September 14, 2015
ADDENDUM #2 to Bid Documents for the
Hidalgo County Regional Mobility Authority
US 281/BSIF CONNECTOR PROJECT CONTRACT NO. 0220-01-023, Etc.
Advertised August 2, August 9, and August 16, 2015

BACKGROUND ON THE CHANGES TO BID DOCUMENTS

ADDENDUM # 2 - PLAN SHEETS MODIFICATION SUMMARY

SCALE: HOR: 1" = 20' VER: 1" = 5'		SHEET 1 OF 9	
DN:	CONT	SECT	JOB
CK DN:	0220	01	023, ETC
DN:	DIST		HIGHWAY
CK DN:	PHR		US 281
TR:	COUNTY		SHEET NO.
CK TR:	HIDALGO		201

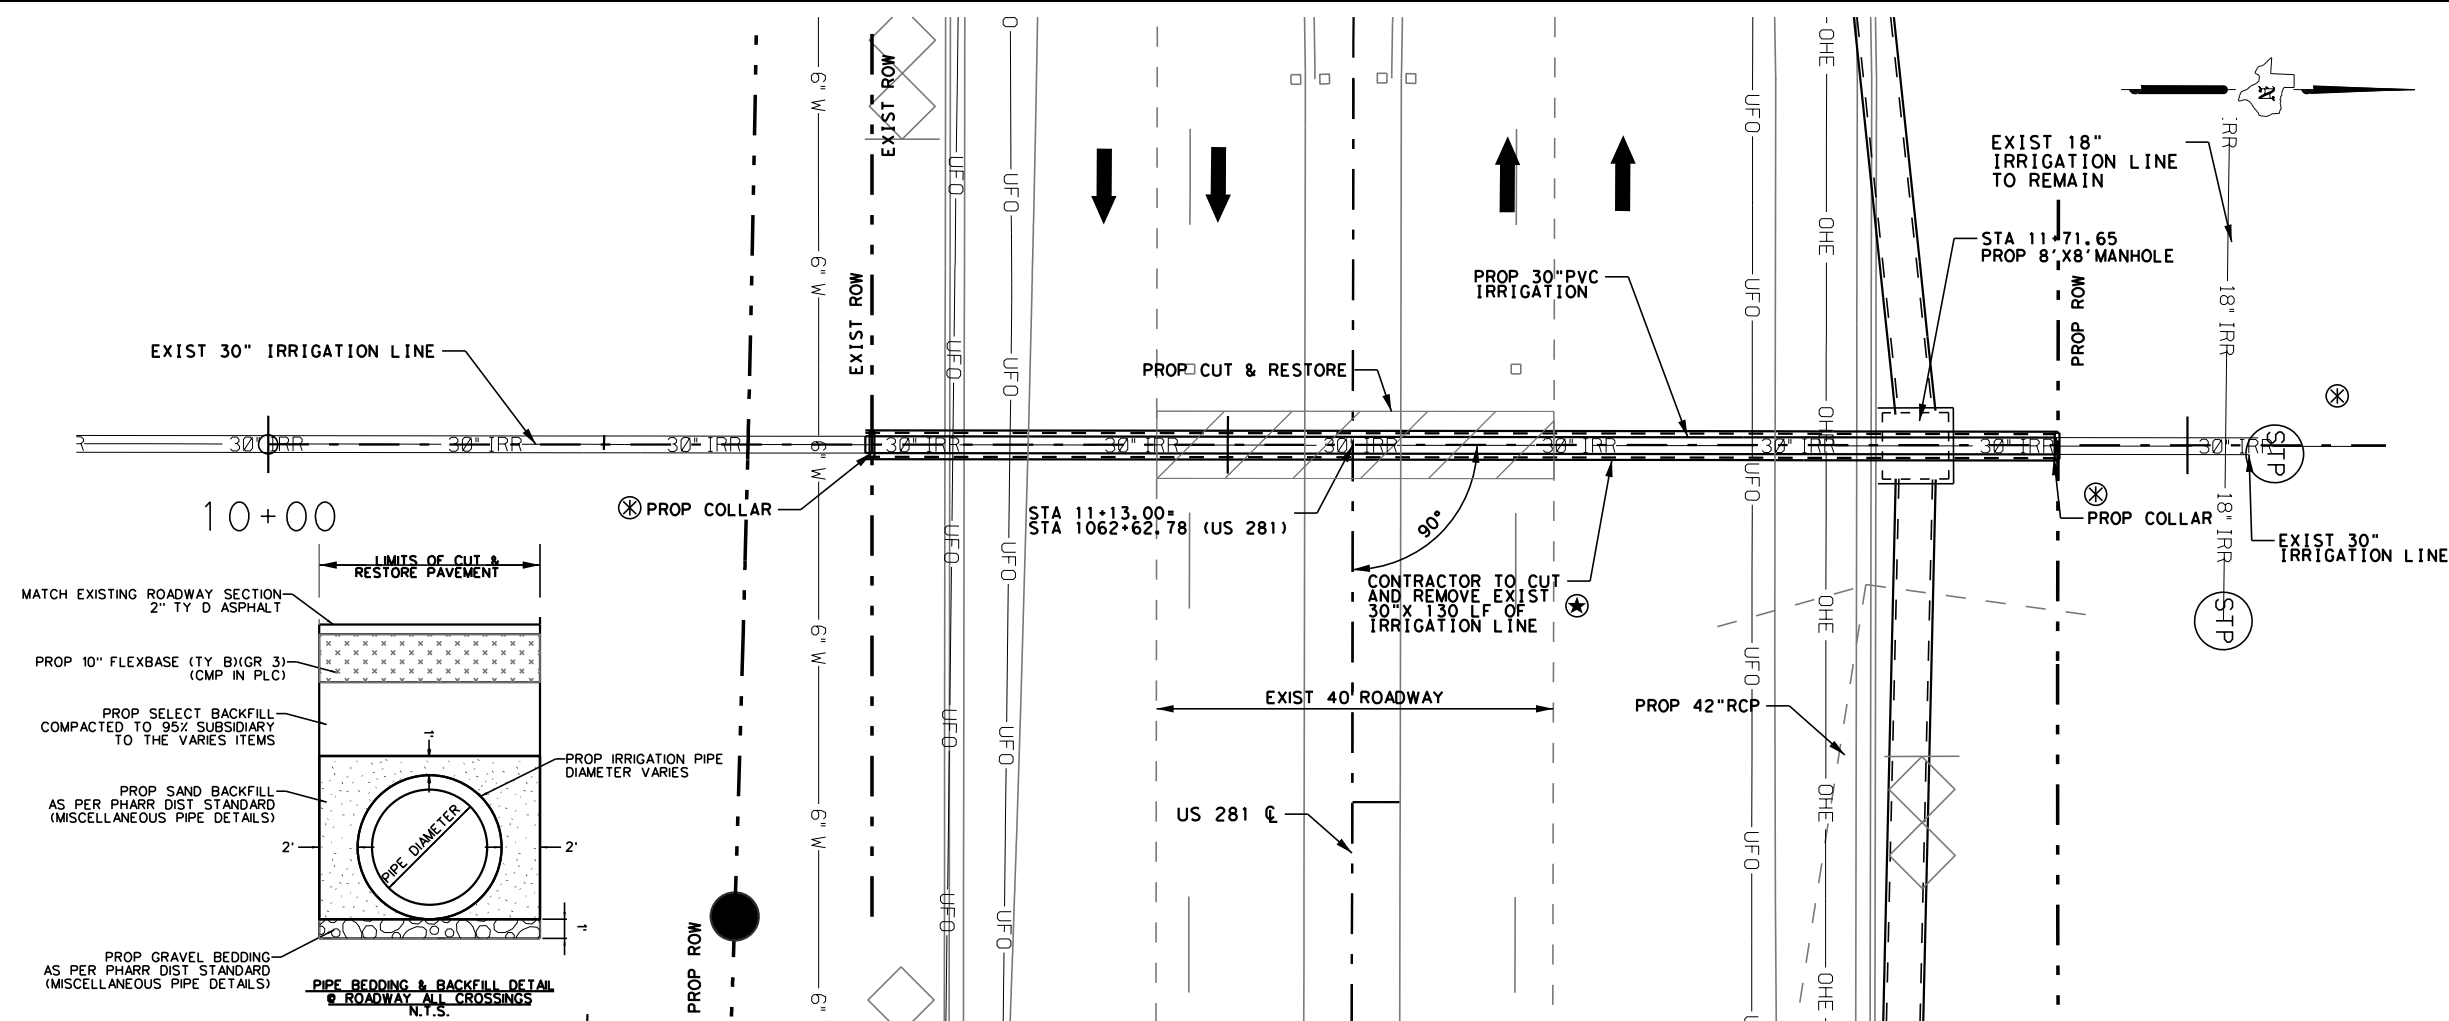
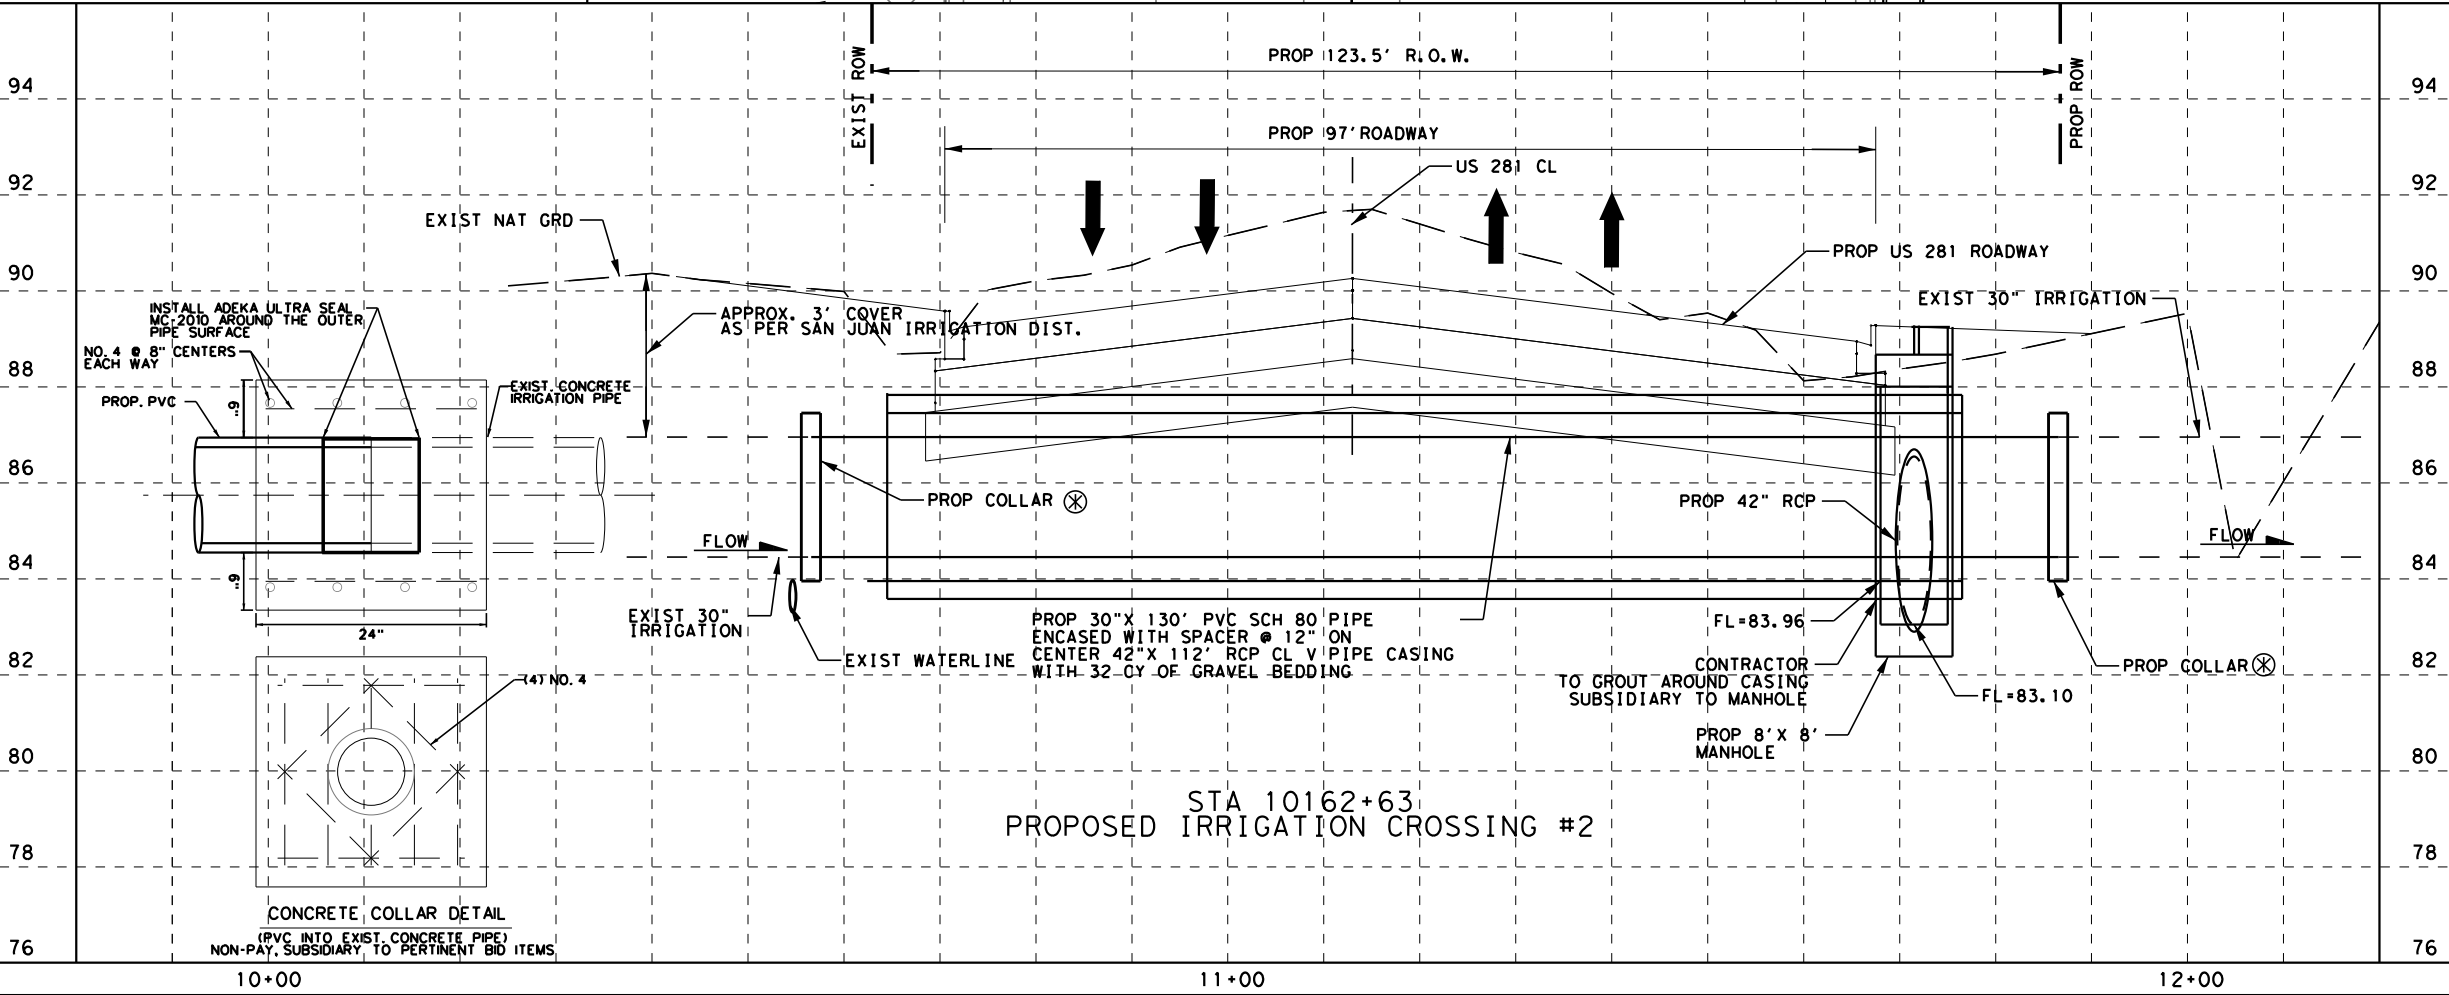
Modified Irrigation Crossing 1-6 as per HCID #2 direction

SCALE: HOR: 1" = 100'		SHEET 1 OF 1	
DN:	CONT	SECT	JOB
CK DN:	0220	01	023, ETC
DN:			US 281
CK DN:	DIST	COUNTY	
TR:	PHR	HIDALGO	
CK TR:			SHEET NO.
			209B

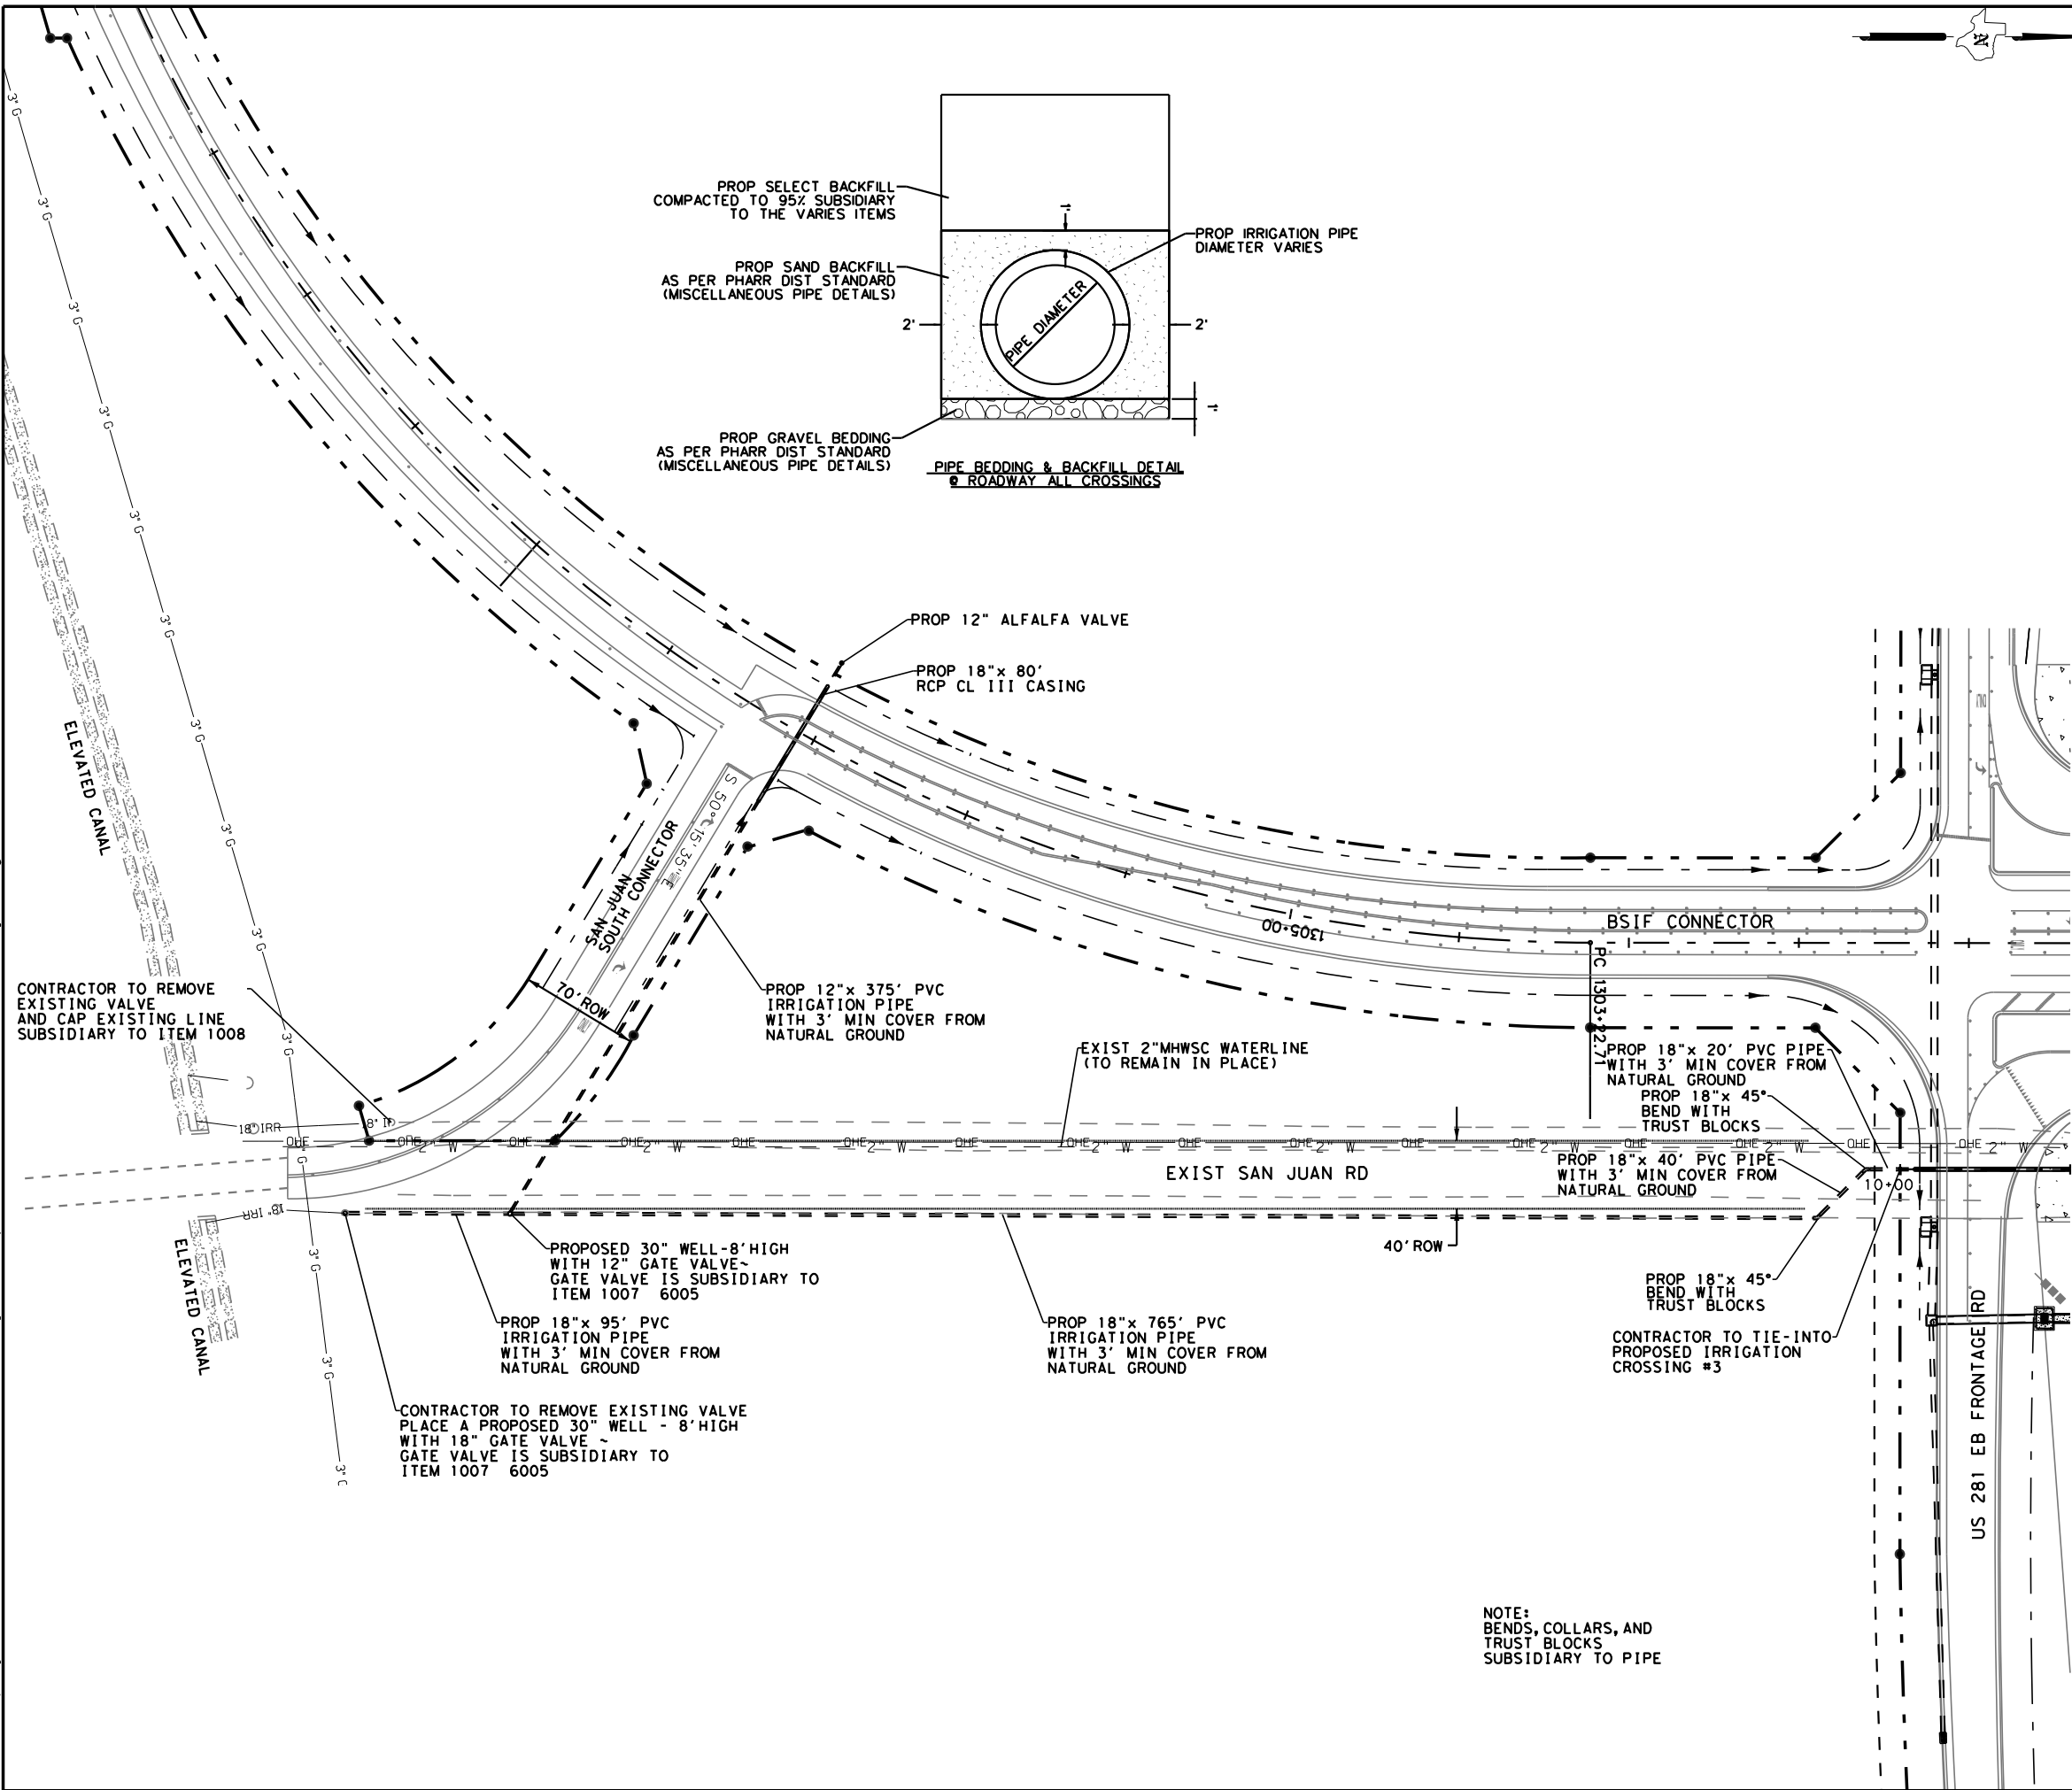
Added Irrigation Layout 209B- as per HCID#2 direction
